Your ref: 24/00494/FUL

### **Drummarnock Wind Farm - NatureScot Response**

I refer to the email dated 12 September 2024 from NatureScot (NS) to Stirling Council in response to the consultation on the application for Planning Permission for Drummarnock Wind Farm (Planning Reference: 24/00494/FUL, the 'Proposed Development'). Having considered the issues raised, the Applicant wishes to make the following representation.

Figure 1-5  
T3 Constraints

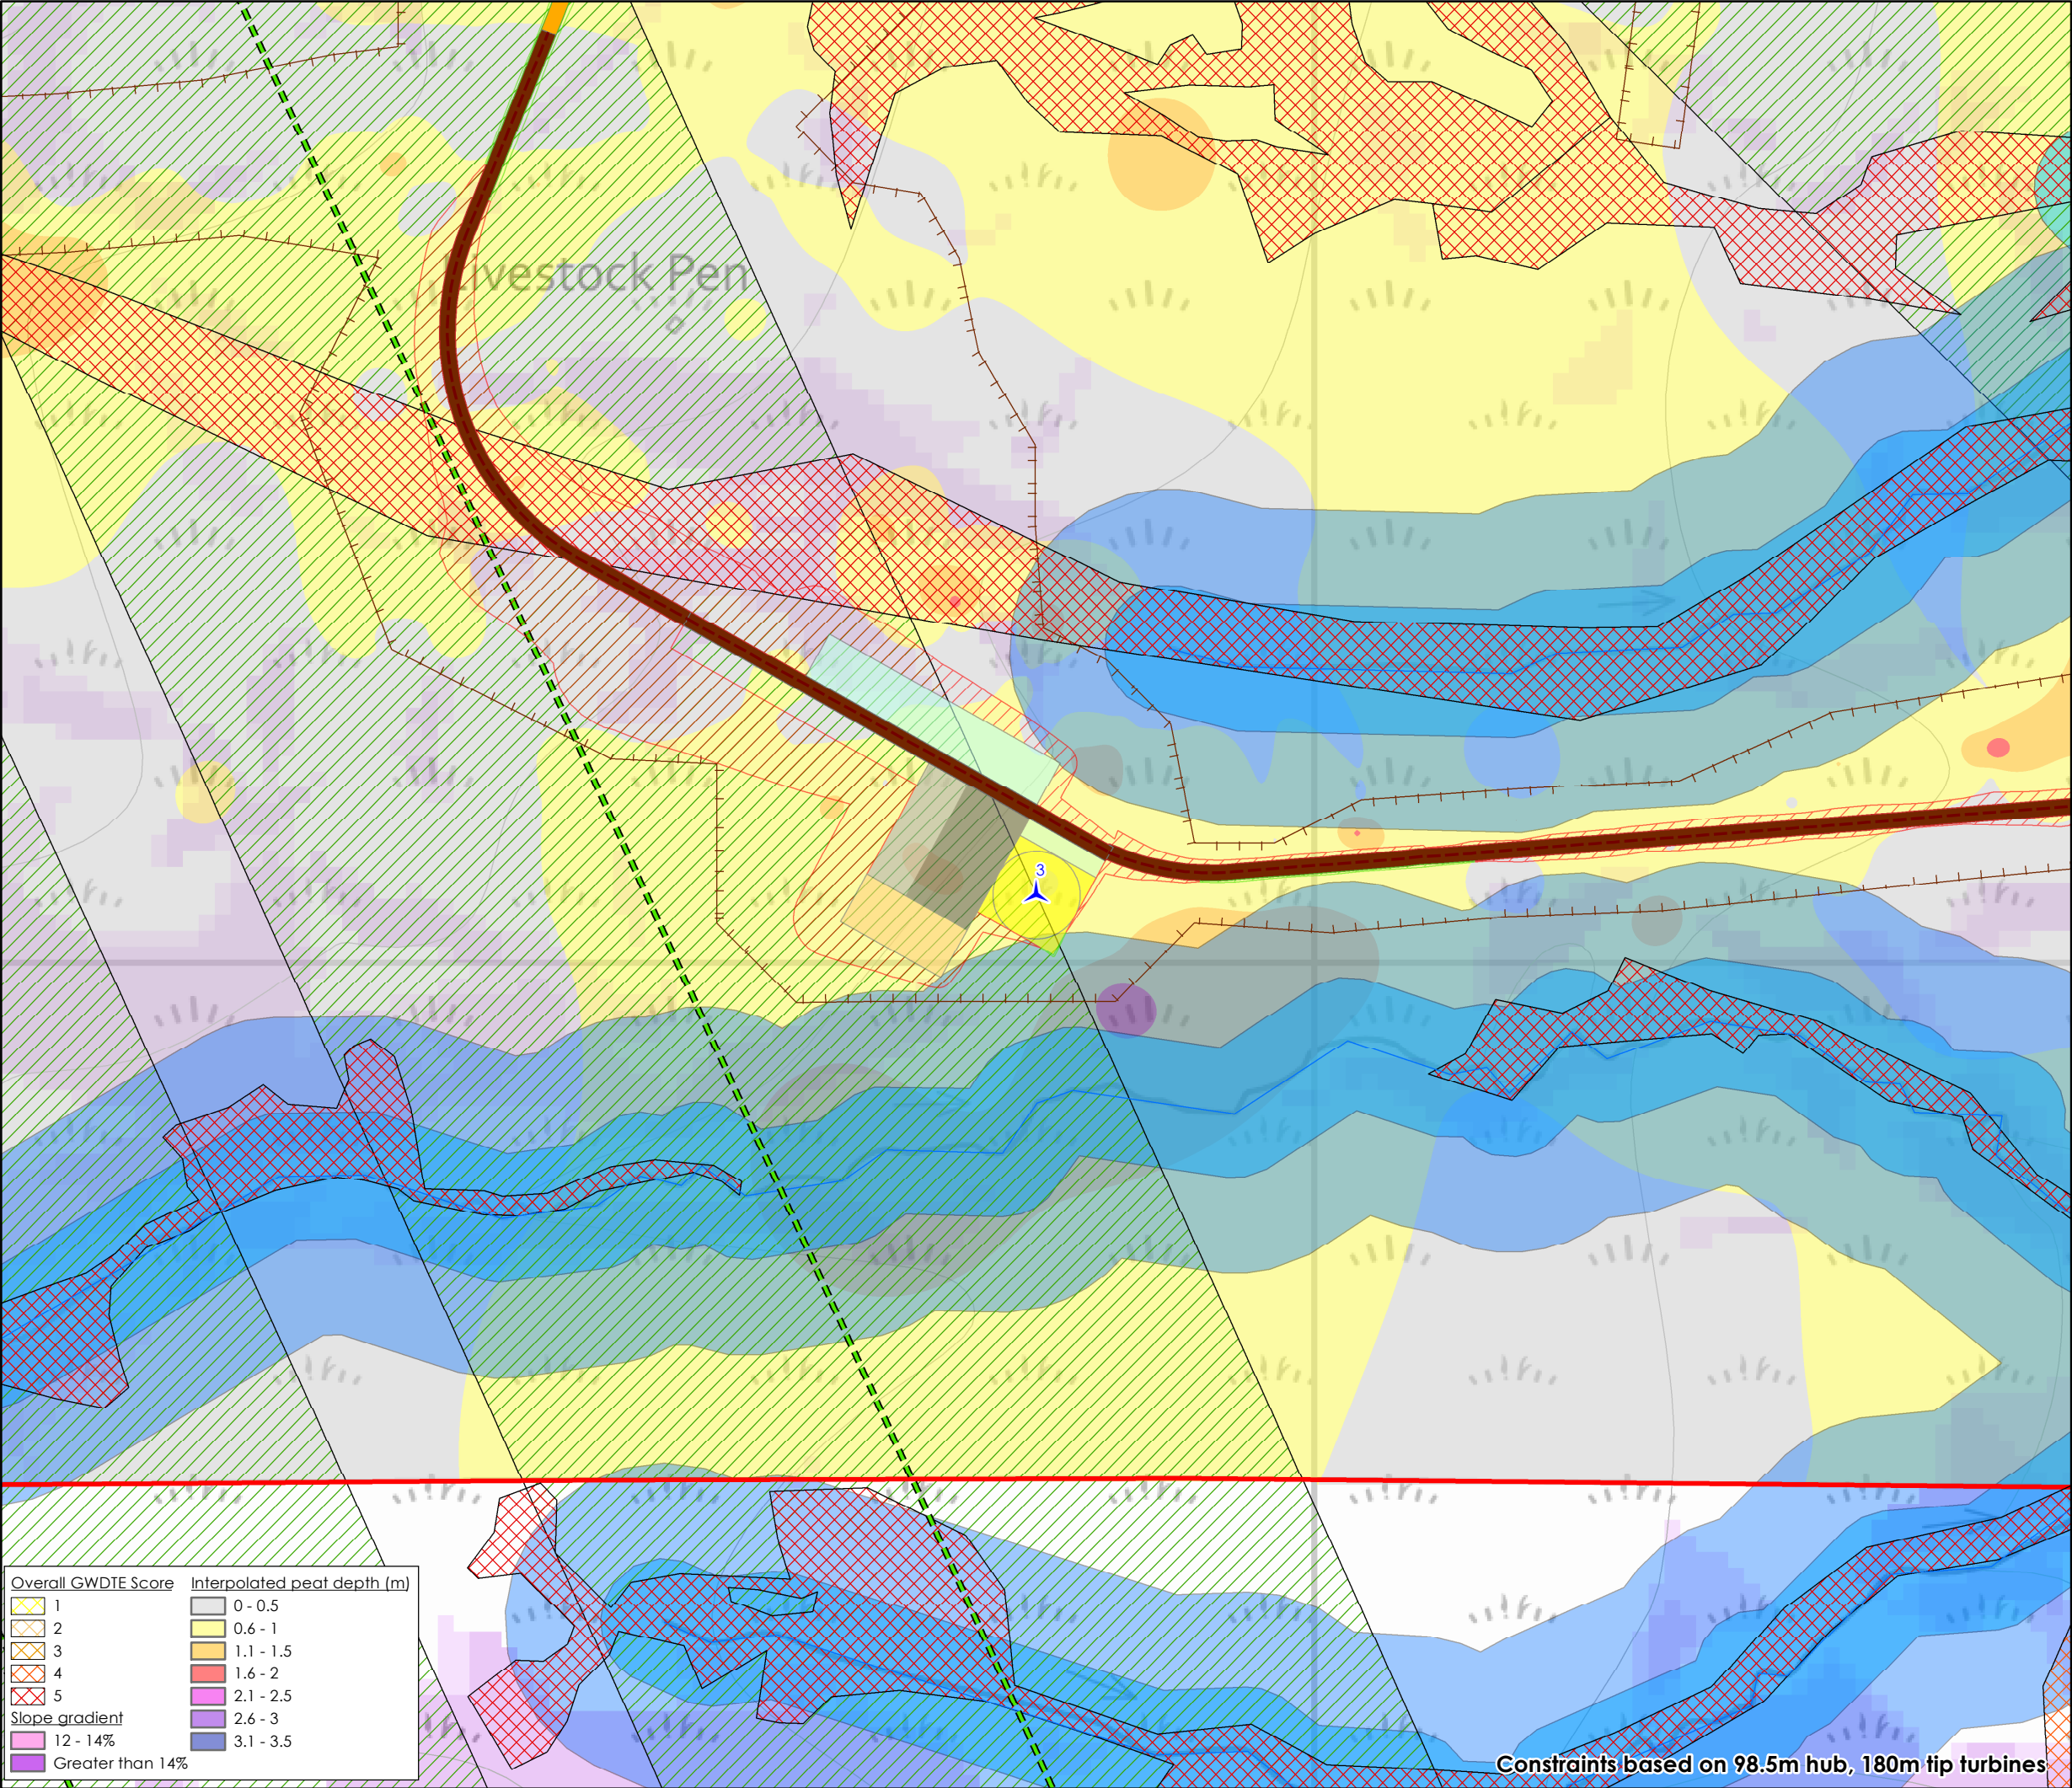
In their response, NatureScot states: *“We advise that areas of deep peat be avoided in line with the mitigation hierarchy... we advise that the applicant considers relocating Turbine 3 in order to avoid any areas of deep peat.”*

The Applicant has carefully considered the location of Turbine 3 (T3) through a detailed analysis of applicable constraints and applied the mitigation hierarchy throughout the design process.

Turbine 3 is currently located on peat between 0.5–1 m depth, with most infrastructure on the southern side of the track and the blade/nacelle storage area on the northern side.

The primary consideration for its location is the avoidance of the point-to-point fixed telecommunications link to the southwest (Ref. 1082233/2), while also minimising encroachment on nearby watercourse buffers to the north and south, highly dependent Ground Water Dependent Terrestrial Ecosystem (GWDTE) to the immediate north, and areas of deeper peat of up to 1.5m depth to the north, east and south.

These constraints are illustrated in Figure 1-5: T3 Constraints (Appendix A).

Relocating the turbine north to the other side of the track would encroach upon a 50 m watercourse buffer and cause direct and indirect loss of highly dependent M6d GWDTE habitat in the elongated valley bottom to the north. Moving northwest would place the turbine on peat up to 2 m deep, offering little or no benefit in reducing deep peat impact.

The Applicant is of the view that the location of the turbine has been optimised to minimise the impact on the environment as a whole. The current location of Turbine 3 has been designed to minimise environmental impacts, is appropriate and compliant with guidance. Any movement of Turbine 3 is anticipated to result in greater environmental impacts due to other constraints on Site.
